GROVE & DALL'OLIO
ARCHITECTS ^{pllc}

**Re: Shepherdstown Opera House Renovation
ADDENDUM No. 1**

The following information amends or supersedes the current issue of architectural, structural, and MEP drawings/specifications dated June 22, 2020.

Patio Trellis

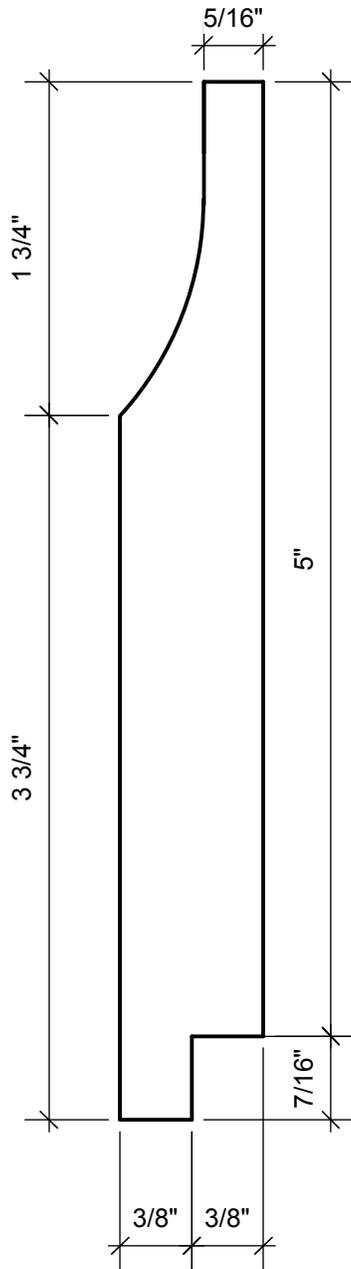
16. 1/A3.2 – The woodwork feature above the patio gate north of the stairwell corner is a trellis. Shown on site plan 1/A1.2. See attached detail of patio trellis, A.SK-1.

POWER RISER DIAGRAM

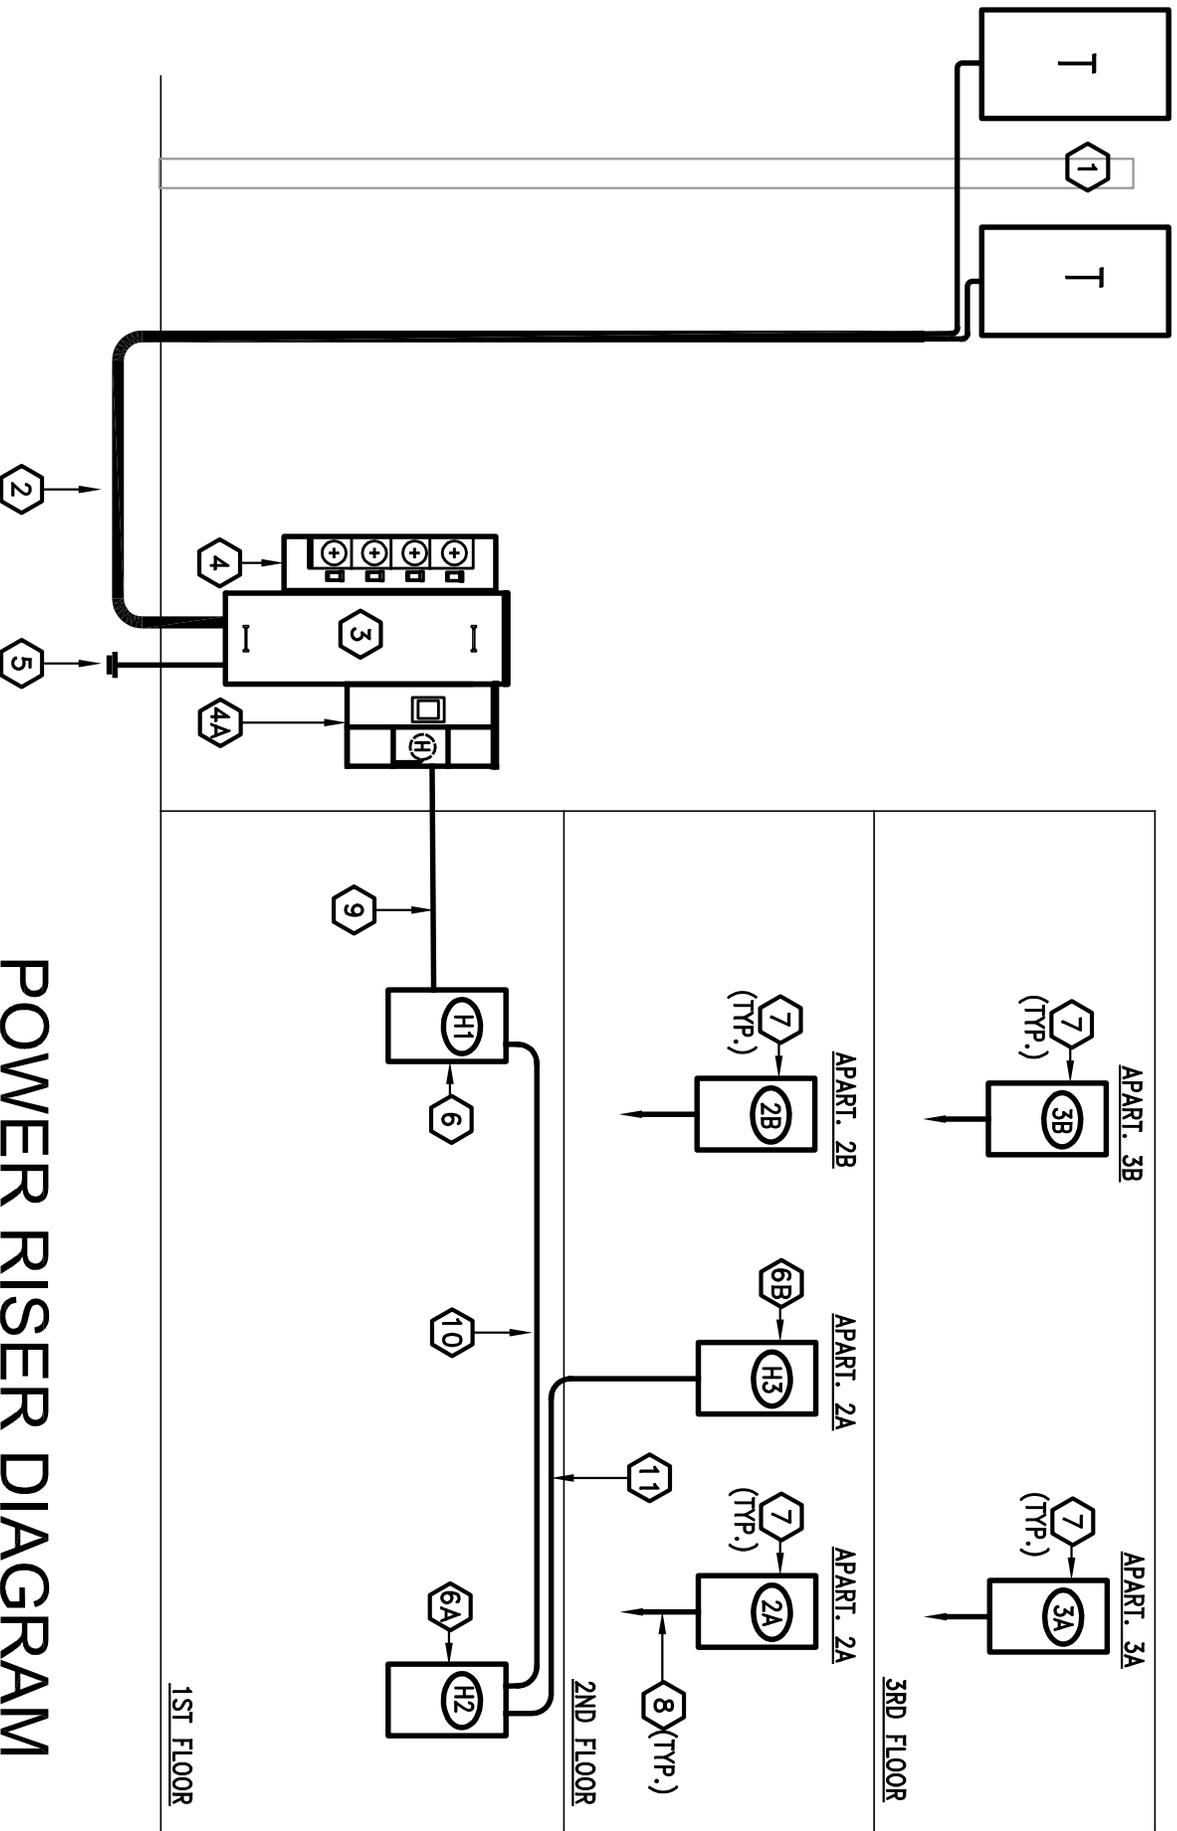
35. Power to the building shall be single phase. See revisions made on E.SK-1 and E.SK-2 sketches.
36. The bid due date has been extended to Friday July 31 at 3pm. Bids are to be emailed to matthew@gdaaia.com.

3. MAIN SWITCHING DEVICE: 240Y/120Vac, 800A, 1∅ INCOMING AND 1∅ OUTGOING W/ MAIN FUSIBLE SWITCHES – SQUARE D MODEL EZM1800FSU OR APPROVED EQUAL.
4. METER STACK: 120/240V, 125A, 4 HOLE, 1∅ INCOMING AND 1∅ OUTGOING, 2–POLE BRANCH CIRCUIT BREAKERS – SQUARE D MODEL EZM114125 OR APPROVED EQUAL. CONTRACTOR TO COORDINATE METER SOCKET CHARACTERISTICS WITH LOCAL UTILITY COMPANY.

- 4A. COMMERCIAL METER STACK: 120/240V, 400A, SINGLE HOLE, 1∅, INCOMING AND 1∅ OUTGOING – SQUARE D MODEL EZML111400 OR APPROVED EQUAL. CONTRACTOR TO COORDINATE METER SOCKET CHARACTERISTICS WITH LOCAL UTILITY COMPANY.

5. TO SERVICE GROUND – SEE DETAIL THIS SHEET.
6. 400A, 120/240V, 1∅, 3W, 65K AIC RATING, 42 POLE, MCB, HOUSE PANELBOARD "H1" – SQUARE D OR APPROVED EQUAL.
